Subject: Request for Additional Information Regarding Root Cause Analysis Report  
(TAC No. MC1642)

By letter dated March 4, 2004, the NRC staff issued a request for additional information concerning the Davis-Besse Nuclear Power Station Unit Number 1 (DBNPS) technical Root Cause Analysis Report, "Significant Degradation of the Reactor Pressure Vessel Head". This report was first submitted to the NRC by the FirstEnergy Nuclear Operating Company (FENOC) under letter Serial Number 1-1270, dated April 18, 2002, and Revision 1 of the report was later submitted under Serial Number 1-1289, dated September 23, 2002. The following provides FENOC's responses to the NRC's request for additional information.

Davis-Besse Top of Reactor Head

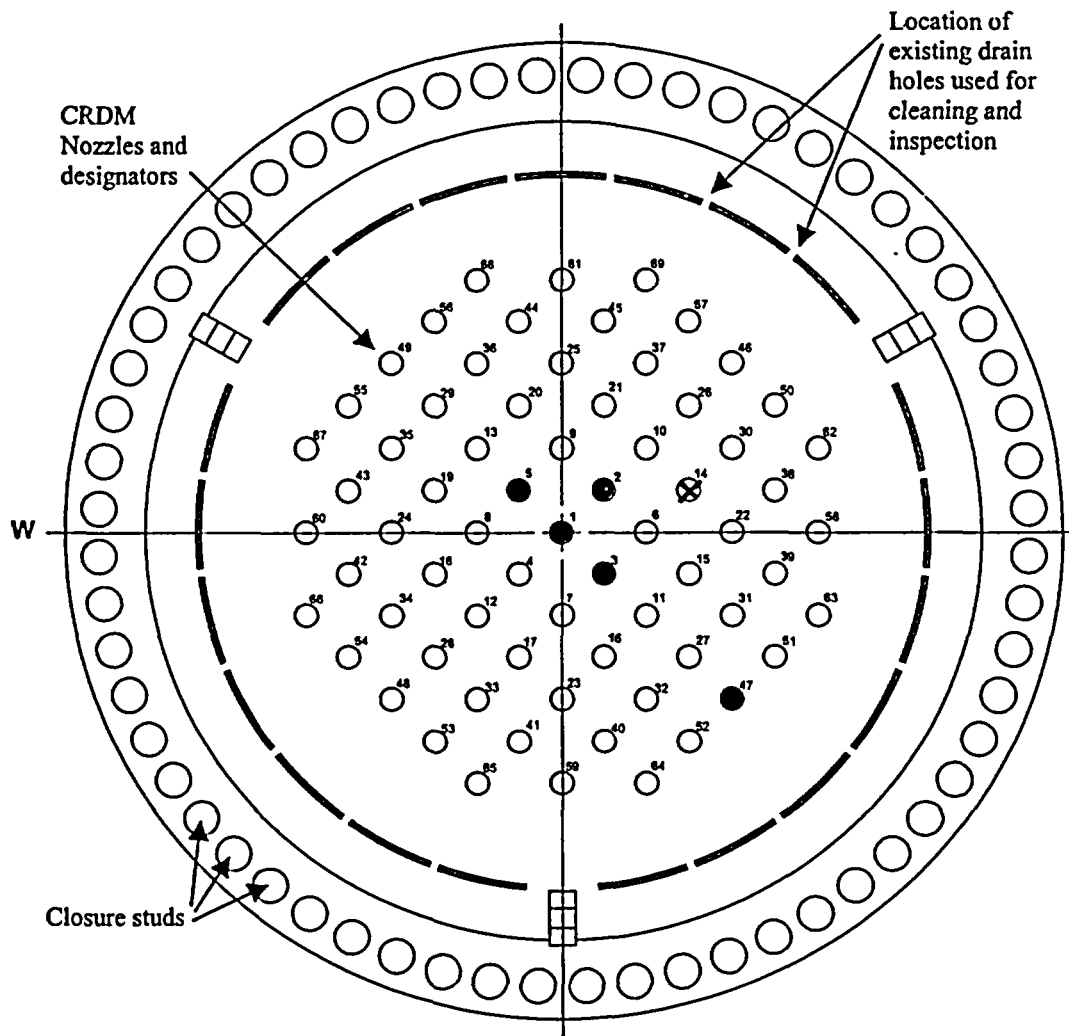
*The purpose of the vent line that runs from nozzle 14 to the steam generator number 2 upper primary hand hole is to vent non-condensable gases from the Davis Besse reactor pressure vessel (RPV) head during a loss of coolant accident. The head vent configuration at Davis Besse is unique from other Babcock and Wilcox (B&W) designs in that reactor coolant flows continuously through it during power operations. Given the proximity of the cracked nozzles in the old RPV head to the vent line nozzle, a phenomenon may exist wherein the continuous flow through the vent line impacts the potential for cracking of nearby nozzles. This same phenomenon, if real, could impact the cracking assumptions for the new RPV head.*

*Confirm whether or not you considered this potential phenomenon in the April 2002 root cause analysis that was performed as a result of the degradation of the old RPV head. If an evaluation was performed, provide the results of the technical analysis that would demonstrate that the phenomenon either did or did not impact cracking in adjacent nozzles. If this potential phenomenon was not considered, provide the technical basis for discounting it. If it was not discounted, but it was never considered, provide a technical basis for why it will or will not play a role in the operation of the new RPV head. If your analysis results show that there is a potential impact on the new RPV head penetrations, discuss the actions that would be taken to ensure the integrity of the head penetrations. Consider whether an update to your root cause analysis report is needed.*

The potential effect of the reactor vessel continuous vent line on increasing the likelihood of nozzle cracking was discussed in Section 3, Data Analysis, of the technical Root Cause Analysis Report (page 12 of revision 0, dated April 15, 2002, and page 15 of revision 1, dated August 27, 2002). Its effect was considered along with other differences of the DBNPS nozzles, such as operating temperature, counterbores, material susceptibility to primary water stress corrosion cracking (PWSCC), and range of interference fits. The potential effect of the reactor vessel continuous vent line was evaluated based on established facts of damage to other nozzles. Among these were:

1. Automated ultrasonic examinations of all 69 Control Rod Drive Mechanism nozzles were performed from beneath the Reactor Pressure Vessel (RPV) head. As reported on page 6 of the technical Root Cause Analysis Report, nozzles 1, 2, 3, and 5 all exhibited flaws. This meant that 4 of the 5 nozzles from Heat M3935 had flaws, and they were all clustered at the top of the head, not around the continuous vent line's nozzle 14 (see attached figure from the technical Root Cause Analysis Report). As discussed on page 16 of the technical Root Cause Analysis Report, Heat M3935 has exhibited a higher PWSCC susceptibility in the industry.
2. The only nozzle with flaws that was somewhat proximate to nozzle 14 itself was nozzle 2.

3. The only other nozzle with a confirmed flaw was nozzle 47, which is on the perimeter of the head, quite some distance from nozzle 14.
4. Overall, it was determined that the head temperatures were sufficiently high to support the initiation of cracks due to PWSCC.

Accordingly, the technical Root Cause Analysis Report concluded the effect of the continuous vent line on the nozzles was very small.
